ADDENDUM NUMBER 02

DATE: 3/8/2023

PROJECT: MHS Band and Choir Renovation

PROJECT NUMBER: 22-1722

FIRST FLOOR - DEMOLITION
PLAN

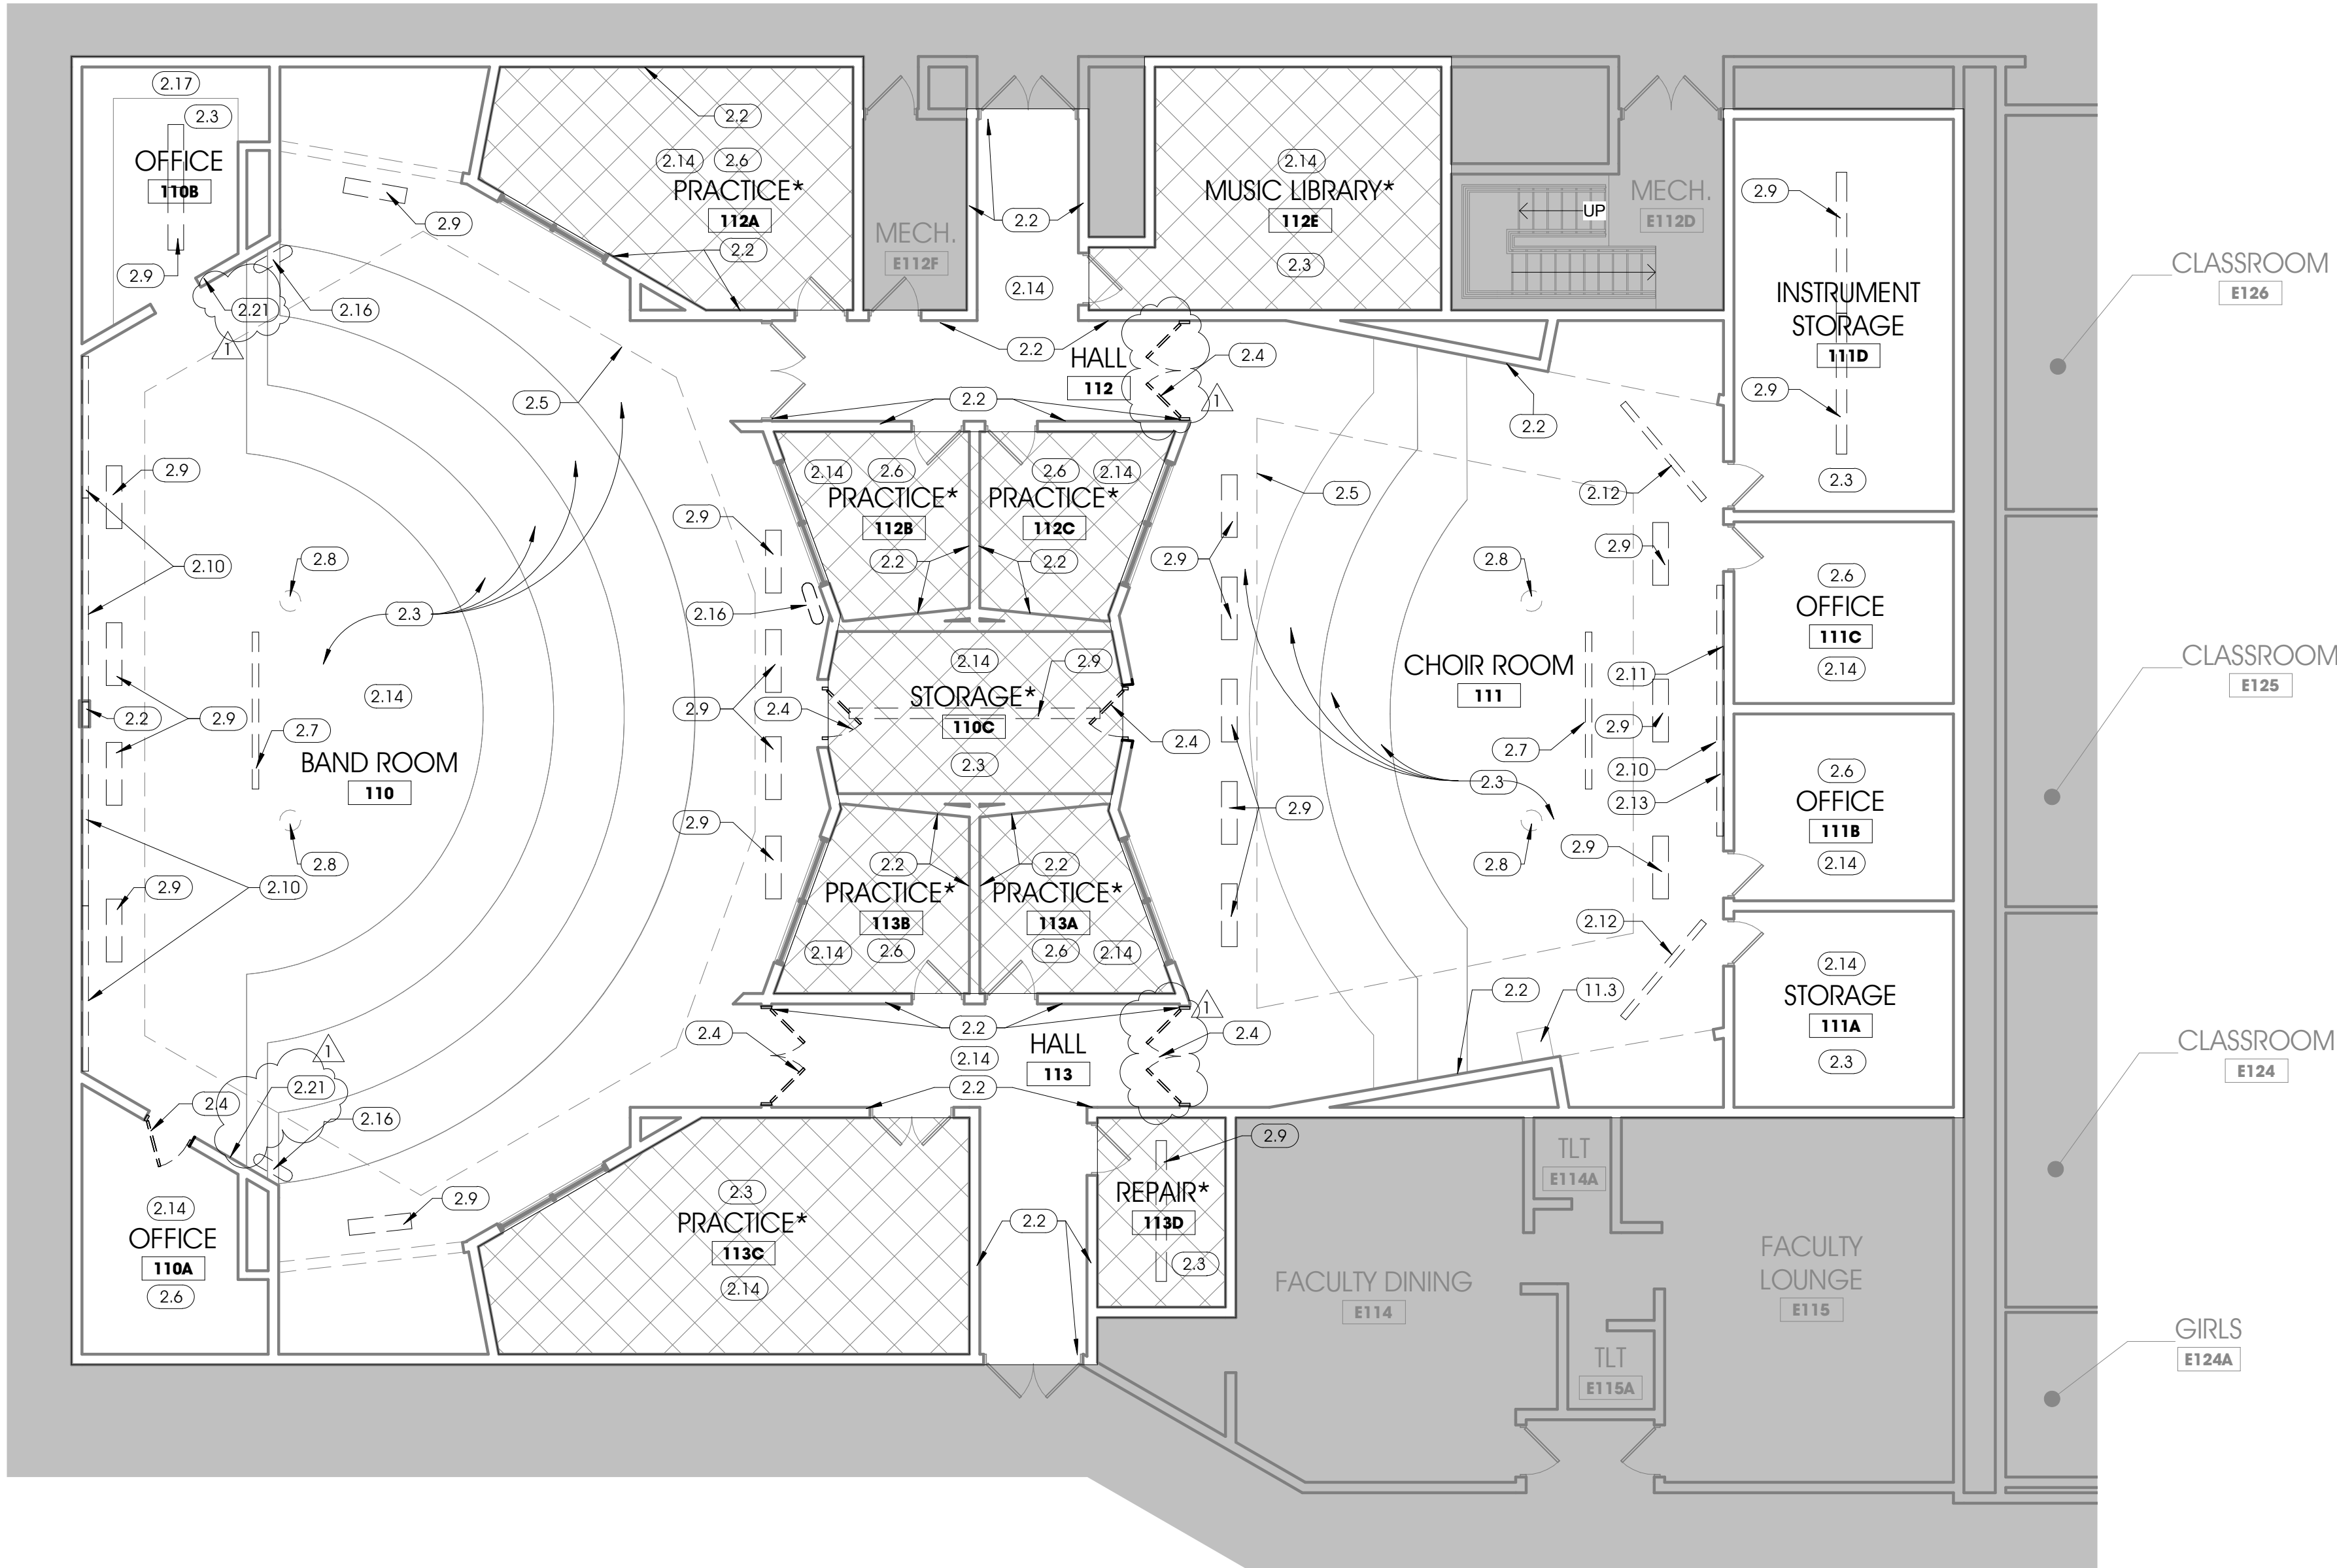
- 2) **ADD** keynote 2.21 to have drywall demolished to studs on exterior walls of band offices 110A & 110B walls after removal of acoustical carpet.

2.16	REMOVE EXISTING WALL HUNG FANS & SALVAGE FOR RE-USE
2.17	EXISTING CABINETRY IN OFFICE 110B TO REMAIN PROTECT DURING DEMO & CONSTRUCTION
2.21	DEMO ACOUSTICAL WALL CARPET & UNDERLYING DRYWALL LAYER TO STUD.

1
A1.1 FIRST FLOOR - CONSTRUCTION PLAN
SCALE: 1/8" = 1'-0"

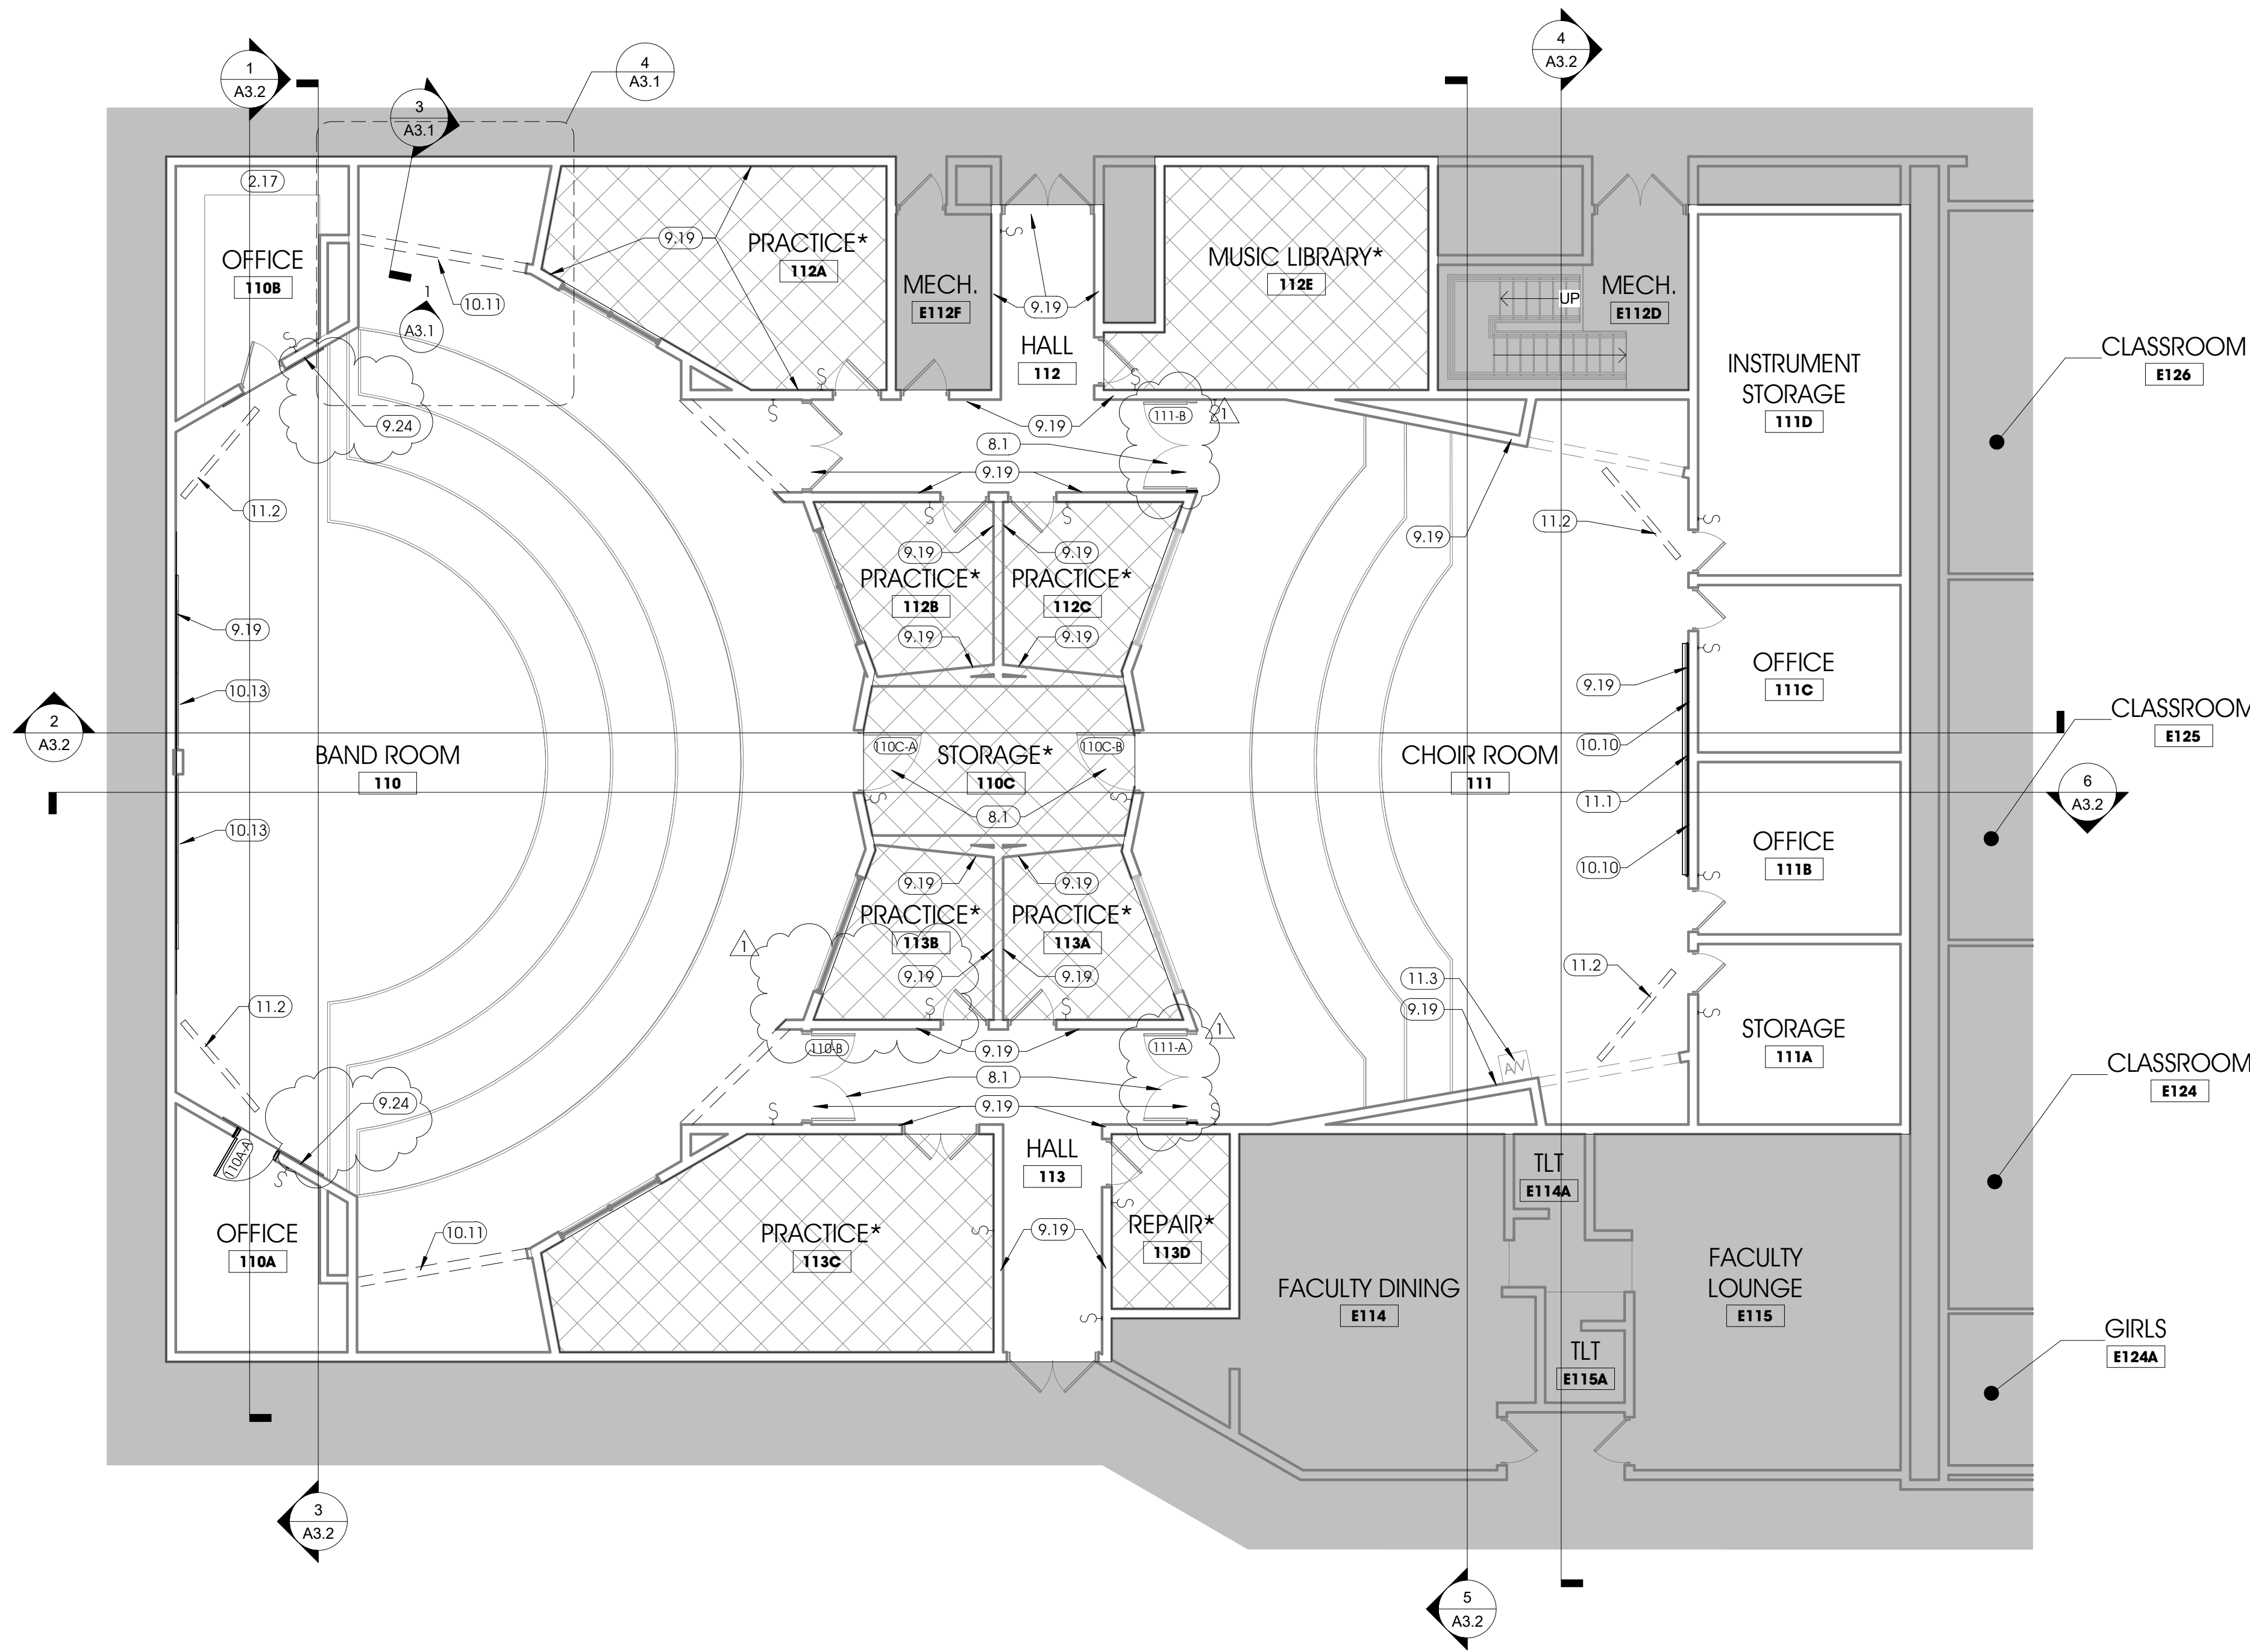
- 3) **ADD** keynote 9.24 to add 5/8" type "x" abuse resistant drywall to exterior walls of offices 110A & 110B and paint with PT-2.
- 4) **CHANGE** references and elevation number from 2/A1.1 to 1/A3.1.
- 5) **DELETE** callout box from Practice Room 113B!
- 6) **DELETE** keynote 8.1 from doors 112-A & 113-A, those doors will not be replaced.
- 7) **DELETE** keynote 10.12 which offered duplicate information about projector screen.
- 8) **DELETE** keynote 10.12 which offered duplicate information about projector screen.
- 9) **MODIFY** keynote 11.1 to give clarity about how to mount salvaged projector screen.
- 10) **MODIFY** keynote 9.19 to remove mention of gypsum. Existing block walls under acoustical carpet are to be skimmed and painted.

9.19	REFINISH WALL AFTER CARPET DEMO. SKIM ALL REVEALED EXISTING BLOCK FROM FLOOR TO CEILING AND FINISH TO LEVEL 4, PAINT WITH PT-2
9.24	ADD NEW 5/8" TYPE "X" ABUSE RESISTANT DRYWALL TO STUDS AND PAINT WITH PT-2
